Administrative Action Preliminary Subdivision

Case File / Name: S-21-16 / Dixon Temple Subdivision

SUBJECT: S-21-16 / Dixon Temple Subdivision

REQUEST: This request is to approve the subdivision of a .514 acre tract, into 2 lots, one 11,892.09 square feet, the other 10,206.09 square feet, both of which are zoned Residential-4.

Preliminary Subdivision Plan

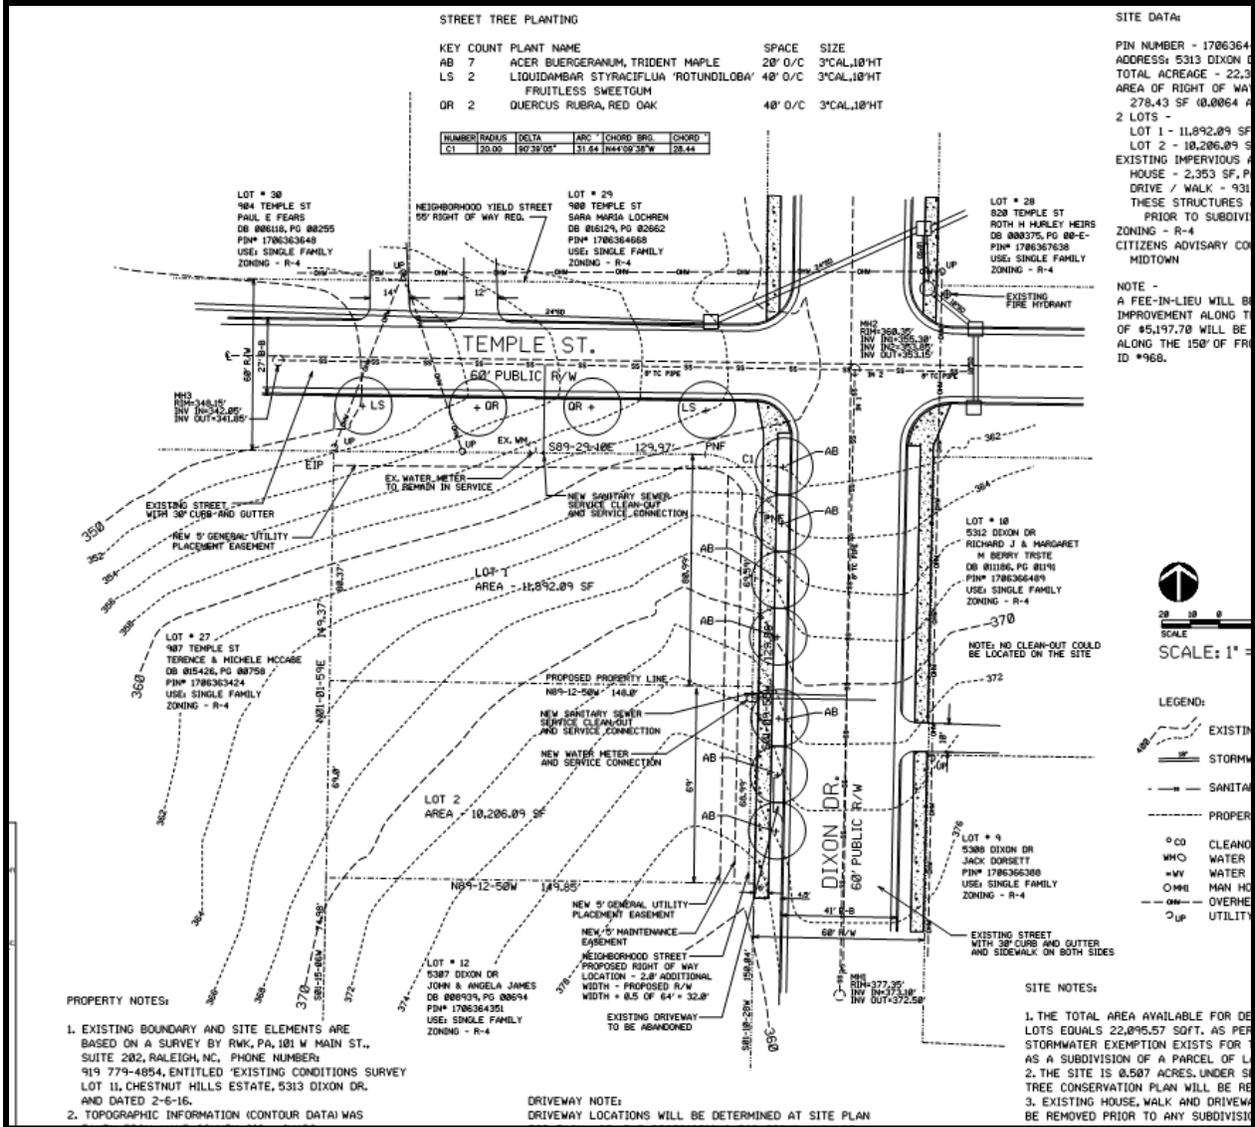
Design Adjustment: One Design Adjustment has been approved by the Public Works Director for this project, noted below.

1. Due to existing infrastructure, a Design Adjustment has been granted allowing an alternative streetscape cross section.

The client will provide street trees in the existing 4.5' strip behind the back of curb, which is adequate space to plant the required trees per Urban Forestry. Staff approves the adjustment for the proposed alternate street-scape.

STREETSCAPE: Existing sidewalk along Dixon Drive is 5' in width. A fee-in-lieu will be charged for 1' of sidewalk. A fee in lieu for a sidewalk 6' in width along Temple Street will be charged. Street trees will be placed behind the existing sidewalk in the right-of-way. A Design Adjustment has been approved for the alternative streetscape cross section. The applicable streetscape is Residential (8.5.2).

OFFICIAL ACTION: Approval with conditions
